CITY OF RIALTO CONTRACT CHANGE ORDER

Date: August 15, 2019
Project No: City Project No. 180804

Project: 2017/18 Annual Street Overlay
Project

Change Order No: 02
Purchase Order 2019-1221
Account 201-500-4310-3001-180804-35
Number(s): 202-500-4317-3001-180804-05
203-500-7305-3001-180804-45
223-500-4414-3001-180804-22

<p>APPROVED BY:  _____ DATE 6/28/16</p>	<p>TRAFFIC SIGNAL STREET NAME SIGN</p>		
		<p>REVISIONS</p>			
DATE	BY	MARK	APPROVED	<p>CITY OF RIALTO, CALIFORNIA PUBLIC WORKS DEPARTMENT ENGINEERING DIVISION</p>	
		<p>STANDARD NO. TS-403</p>	<p>SHT 1 OF 2</p>

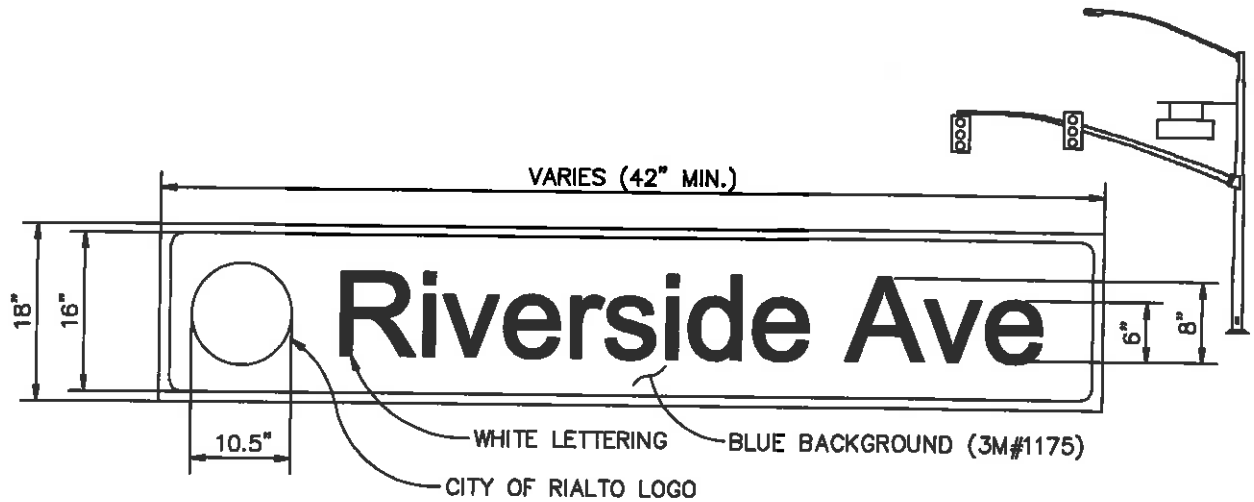
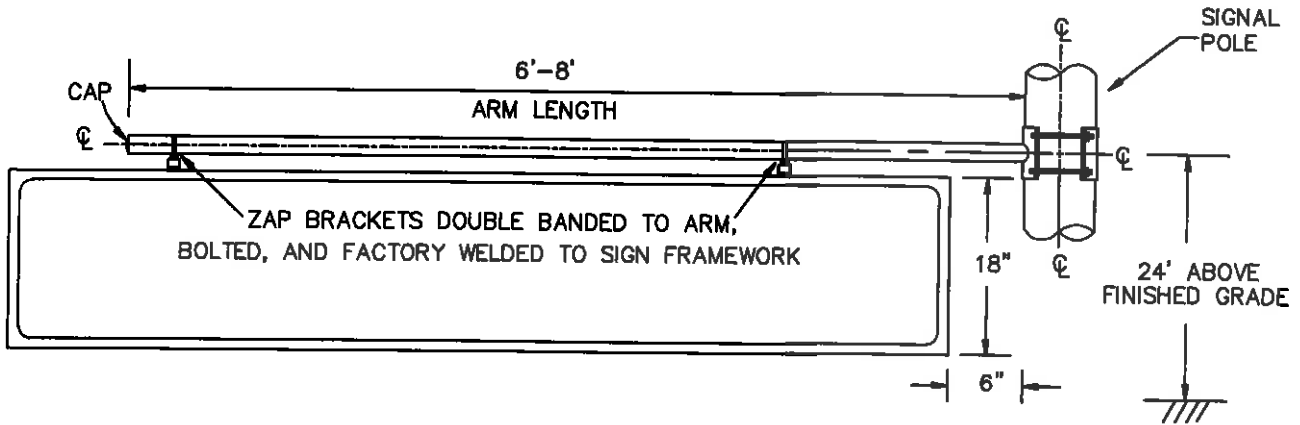
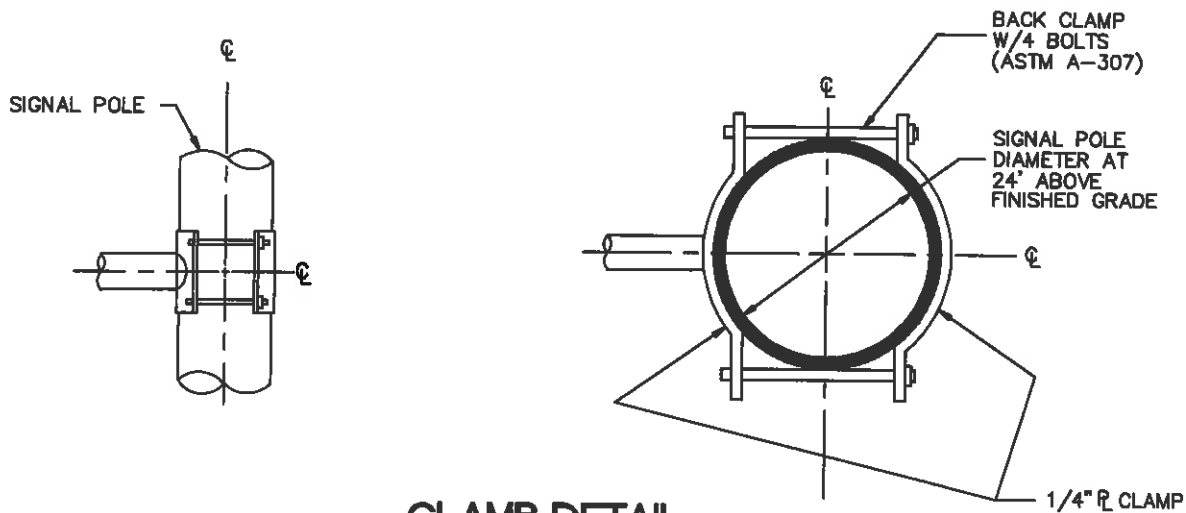
Question 2. Confirm whether the SNS is to be LED internally illuminated or reflective? The plans refer to the City Standard TS-403 and to match the other signs at the intersection. TS-403 refers to reflective signs, and the existing signs are also reflective.

Question 3. The black color shown in the artwork is the frame of the sign. Does the City want the frame in another color?

Additional Comment: This sign is item 23 on Bid Schedule B, and is specified as an internally illuminated sign. Because of the change to a reflective sign there should be a cost reduction. Please provide a revised cost for the reflective type sign.

Response 2. The City wants to have the new sign match the existing signs. Therefore, the new sign should be reflective type, conforming to TS-403. See attached photo of one of the existing signs. Also see attached Gexpro submittal as an example of a similar sign that meets City requirements. Please note that the City requires a sign safety cable as indicated in the Gexpro submittal.

Response 3. The frame color should be white, matching the existing signs, and similar to the Gexpro submittal sample.
